**LEEDS EAST
AIRPORT**

**AIRSPACE CHANGE PROPOSAL
ACP-2016-013**

**RNP
INSTRUMENT APPROACH PROCEDURES**

Addendum for minor change to aircraft approach classification
to

Figure 2. – Chart showing previous procedure route for Runway 06

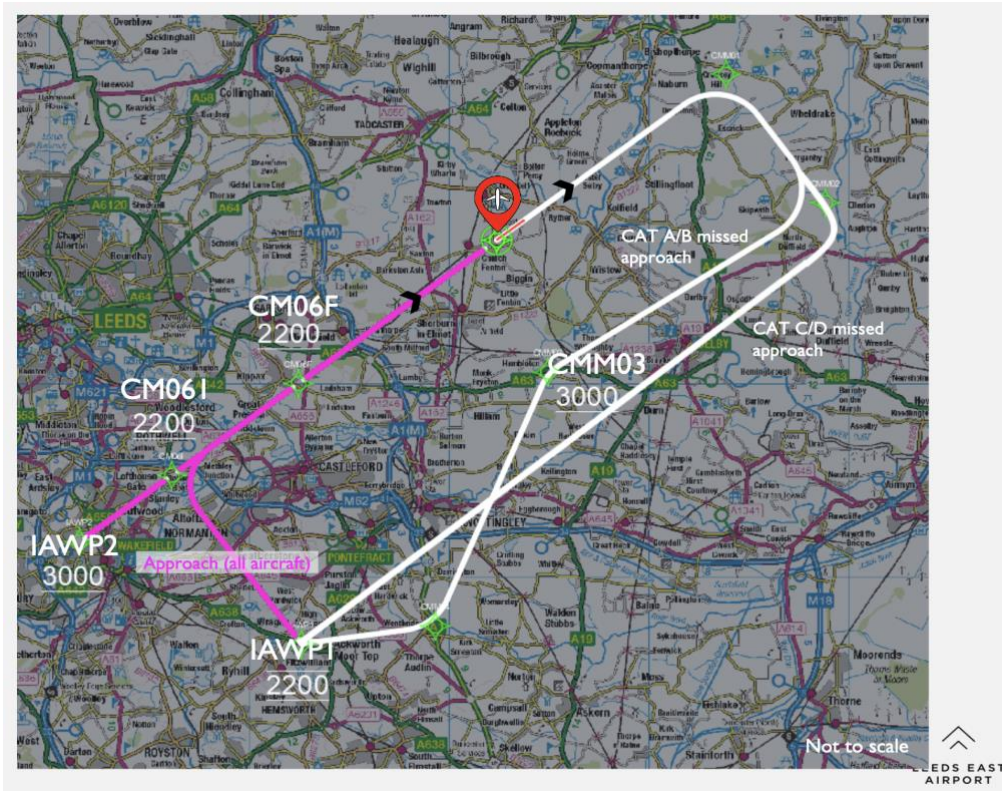
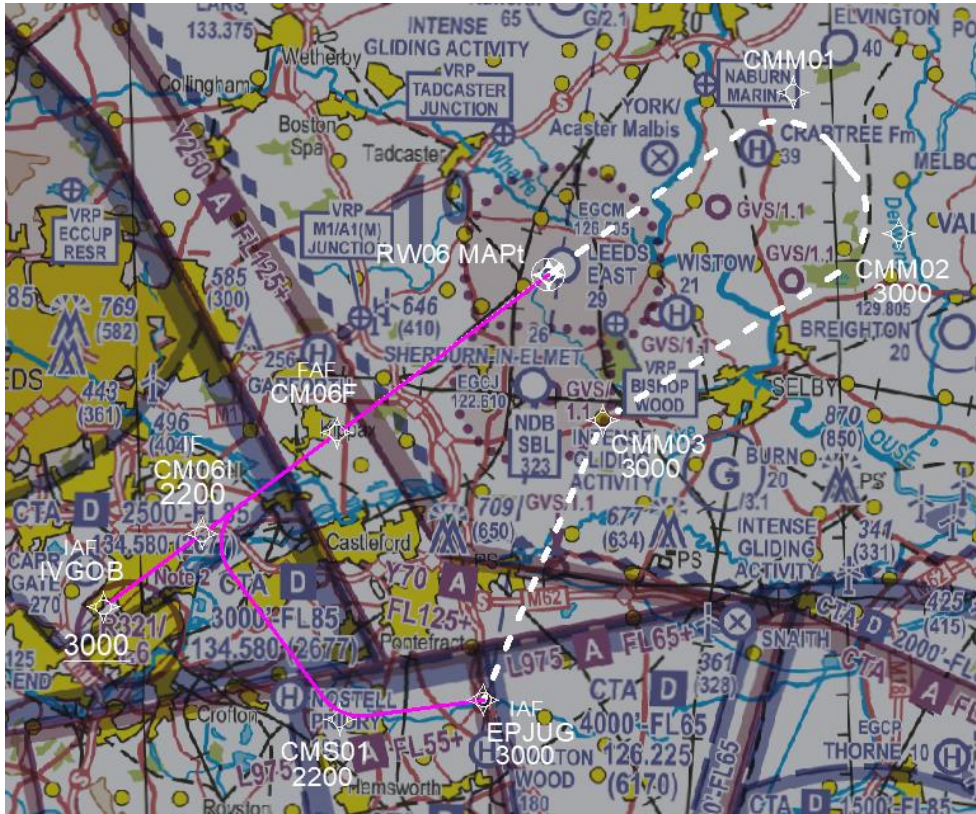
3.1 In the consulted designs (Figs 2 & 3) aircraft in CAT C & D followed a different larger flightpath if, in the unlikely event, a missed approach became necessary. In revised Figs 3 & 4 there is now only one smaller flightpath route that all aircraft will follow on a missed approach.

3.2 Therefore, on a Runway 06 missed approach ALL aircraft route to the Sherburn Aero Club ATZ, thus keeping clear of Burn. Aircraft are required to reach an altitude of 3000 feet before turning southwest at waypoint CMM02.

3.3 The APDO also advised inserting a new Initial Approach Fix (IAF) along that route at 3000 feet to help aircrew manage their vertical flightpath. From this new waypoint now designated as EPJUG aircraft will descend to an altitude of 2200 feet at the waypoint previously designated BATLI now CMS01 for another approach.

Figure 4. – Chart showing revised procedure route for Runway 06

Figure 5. – Chart showing revised procedure route for Runway 24

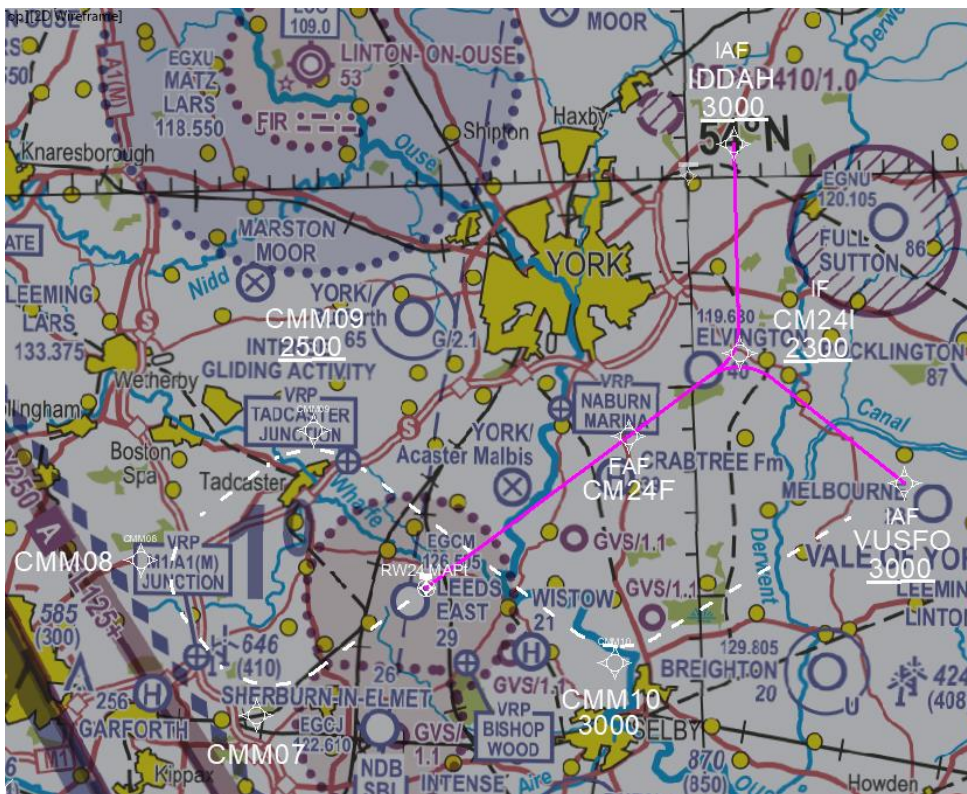
3.4 Similarly in respect of Runway 24, ALL aircraft must reach an altitude of 2500 feet by waypoint CMM09 before turning well short of the Rufforth West gliding site and onto a south-easterly heading as they position to VUSFO for another approach.
